PLANNED UNIT DEVELOPMENT,
SUBDIVISION &
SIDEWALK WAIVER REQUEST
STAFF REPORT

Date: October 7, 2010

<u>NAME</u>	The Learning Tree
<u>SUBDIVISION NAME</u>	Primo Commercial Park Subdivision, Resubdivision of Lots 7 & 8
<u>LOCATION</u>	5459 Able Court (Southeast corner of Able Court and Cottage Hill Road)
<u>CITY COUNCIL DISTRICT</u>	District 4
<u>PRESENT ZONING</u>	B-3, Community Business District
<u>AREA OF PROPERTY</u>	1 Lot / 1.3 \pm Acres
<u>CONTEMPLATED USE</u>	Planned Unit Development approval to allow multiple buildings on a single building site, Subdivision approval to create 1 lot, and Sidewalk Waiver approval to waive construction of sidewalks along Able Court and Cottage Hill Road.
<u>TIME SCHEDULE FOR DEVELOPMENT</u>	New construction to begin within 90 days of approval.
<u>ENGINEERING COMMENTS</u>	<p>Show Minimum Finished Floor Elevation on each lot on Plat. Also show the FFE on the plat for the existing buildings. There is to be no fill placed within the limits of the flood plain without providing compensation. Must comply with all storm water and flood control ordinances. Any work performed in the right of way will require a right of way permit.</p> <p>There does not a

SITE PLAN

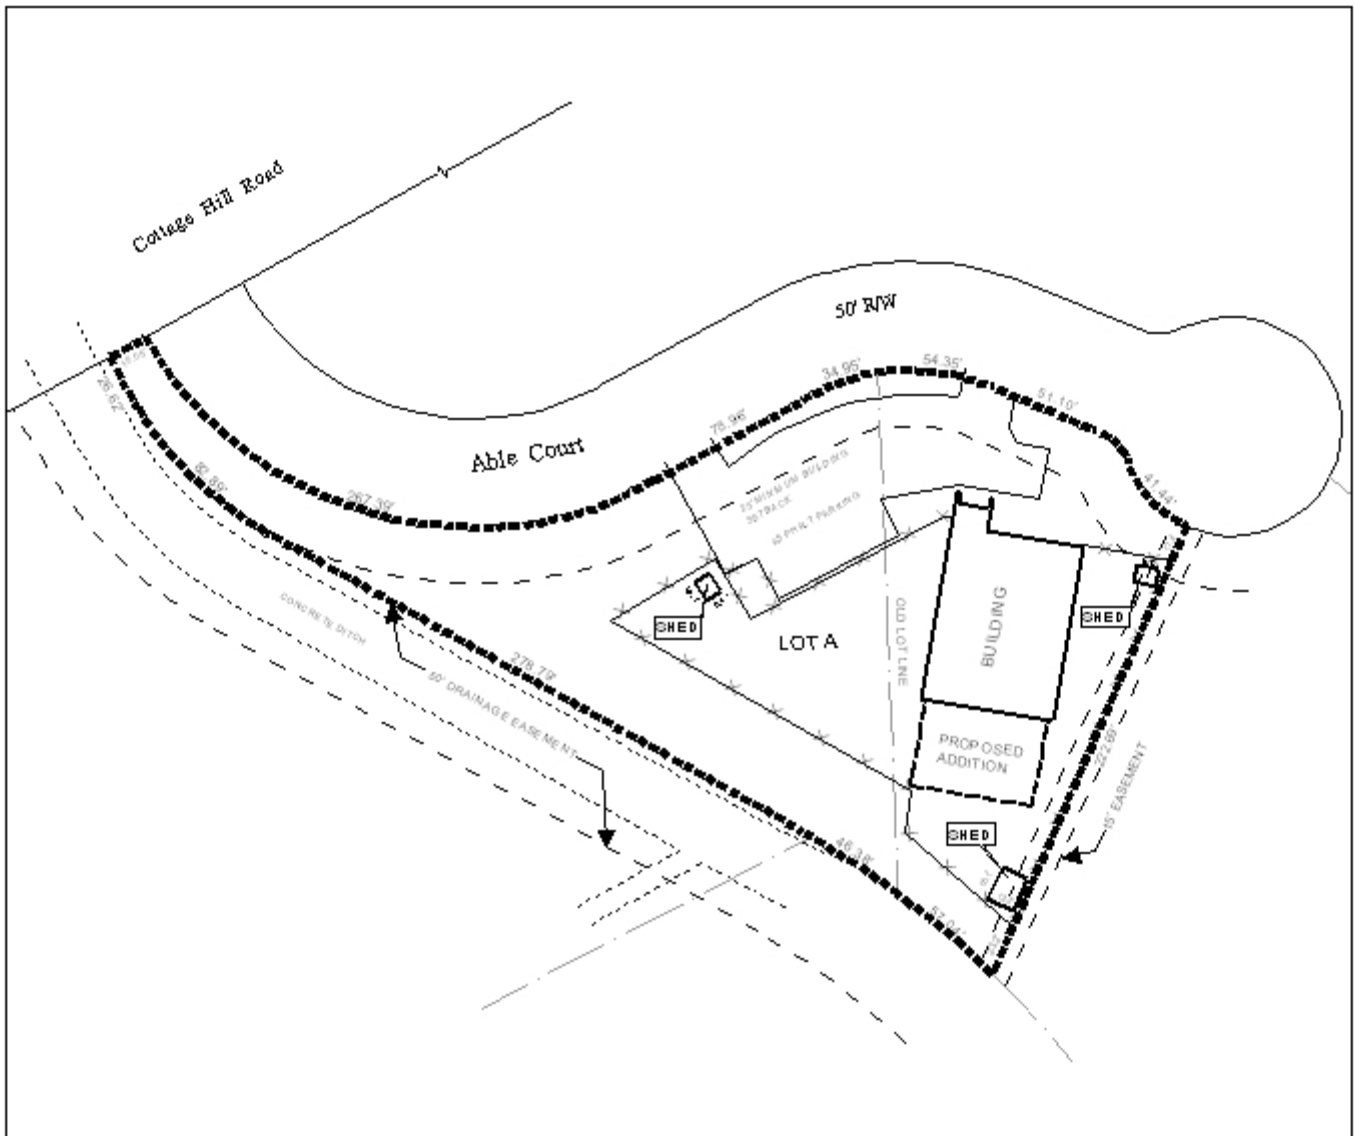
The site fronts Cottage Hill Road, a planned major street, and Able Court, a minor street. The Major Street Plan component of the Comprehensive Plan calls for 100-feet of right-of-way for Cottage Hill Road: the existing width of the right-of-way is not depicted on the preliminary plat, as required, but GIS data appears to indicate that the right-of-way exceeds the minimum requirements at this location. Able Court has the minimum required 50-foot right-of-way. The plat should be revised to label the right-of-way width of Cottage Hill Road.

Access management is a concern due to the proximity to a proposed major street and due to existing topographic conditions. The site has two existing curb-cuts onto Able Court, and no additional curb-cuts are proposed. A note should be placed on the site plan and plat stating that direct access to Cottage Hill Road is denied, and that the site is limited to the two existing curb-cuts onto Able Court.

Parking for day care facilities is determined utilizing a ratio of one and one half parking spaces per teaching station. A total of seven (7) teaching stations will exist within the building upon completion of the expansion, thus eleven parking spaces will be required: aerial photos indicate that thirteen exist on the site (although the 2006 aerials do not appear to show any parking spaces compliant with the requirements of the Americans with Disabilities Act). The site plan should be revised to depict all paved parking spaces.

As previously mentioned, the PUD is required due to multiple structures on the site. Three storage sheds were placed on the property without permits, and two of these sheds are located within drainage/utility easements and floodplains, and less than 8-feet from the property line. The applicant should be required to obtain after the fact permits for all sheds, and the sheds located within the drainage/utility easements should be located to be outside of the easements and meet any required setbacks. Any sheds within the floodplain must comply with the applicable requirements.

No dumpsters are depicted on the site, however, aerial photos indicate that a dumpster may in fact exist on the site. The site plan should be revised to depict any existing or proposed dumpsters.

The existing play areas are not depicted on the site plan, and it also appears that existing chain link fences were replaced with wooden privacy fences, without the appropriate permits. Permits should be obtained for any new fencing placed on the property.

The plat and site plan do not indicate the size of the proposed lot. Both should be revised to include the lot size in square feet.

- 1) Revision of the site plan to depict the relocation of two of the existing storage sheds to meet all minimum setback requirements and to be outside of any drainage/utility easements, and the obtaining of building permits for all three sheds at the time of permitting for the building addition;

- 2) Revision of the site plan to depict the existing play areas;
- 3) Revision of the site plan and plat to label the right-of-way width of Cottage Hill Road;;

- 4) Revision of the site plan to depict all parking spaces (and review to ensure compliance with the requirements of the Americans with Disabilities Act);

- 5) Revision of the site plan to depict any existing or proposed dumpsters;
- 6) Placement of a note on the site plan and plat stating that the lot is limited to the two existing curb-cuts onto Able Court, and that direct access to Cottage Hill Road is denied;

- 11) Labeling of the lot size in square feet;
- 12) Provision of a revised PUD site plan to the Planning Section of Urban Development prior to the signing of the final plat or the obtaining of permits; and
